UNITED STATES PATENT AND TRADEMARK OFFICE

| APPLICATION NO. | FILING DATE | FIRST NAMED INVENTOR | ATTORNEY DOCKET NO. | CONFIRMATION NO. |
|---------------------------------|-------------|----------------------|---------------------|------------------|
| 10/789,357 | 02/27/2004 | John Popovich | PERMLT.019C1 | 5148 |

Office Action Summary

FIG. 16

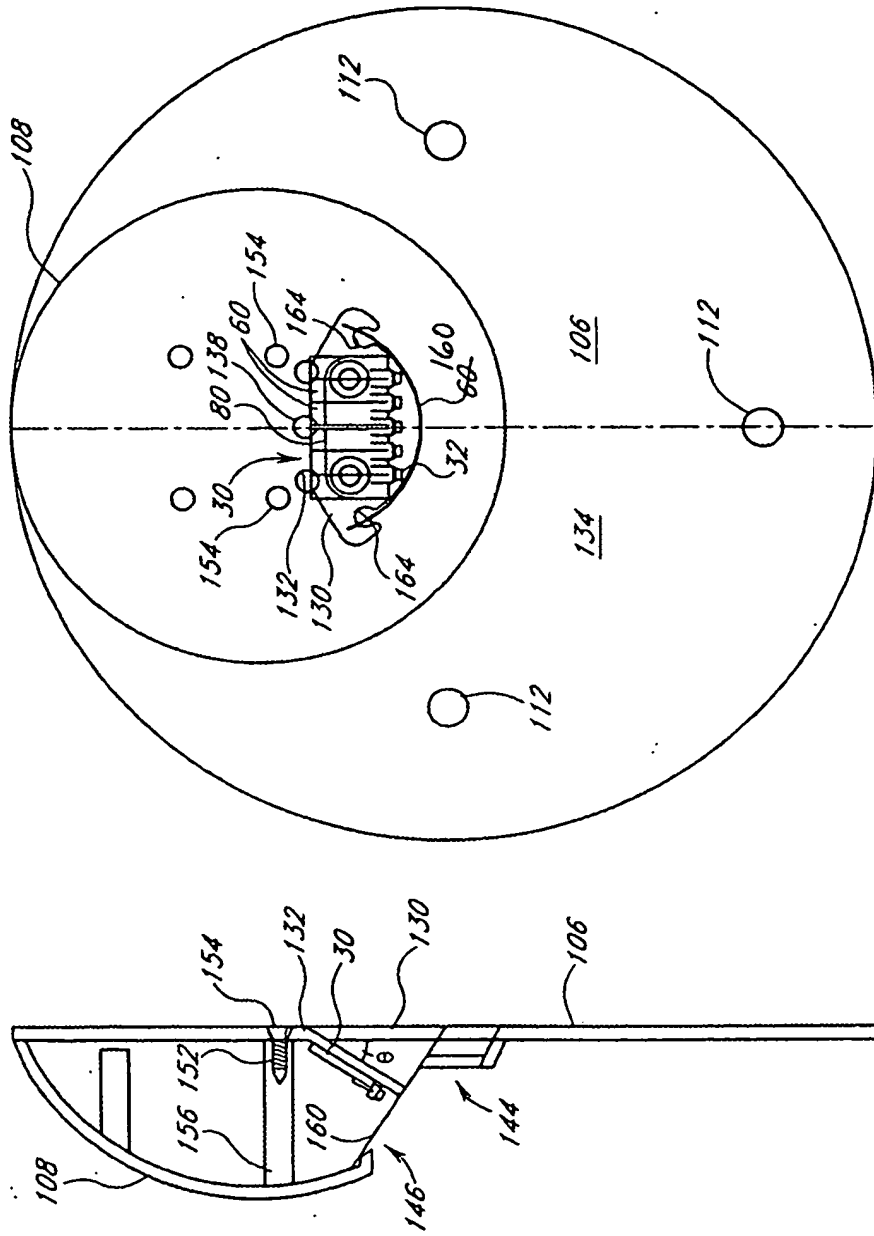
The drawings are objected to because in figure 16, applicant should change "60" to ~~160~~ (note attachment). Corrected drawing sheets in compliance with 37 CFR 1.121(d) are required in reply to the Office action to avoid abandonment of the application. Any amended replacement drawing sheet should include all of the figures appearing on the immediate prior version of the sheet, even if only one figure is being amended. The figure or figure number of an amended drawing should not be labeled as "amended." If a drawing figure is to be canceled, the appropriate figure must be removed from the replacement sheet, and where necessary, the remaining figures must be renumbered and appropriate changes made to the brief description of the several views of the drawings for consistency. Additional replacement sheets may be
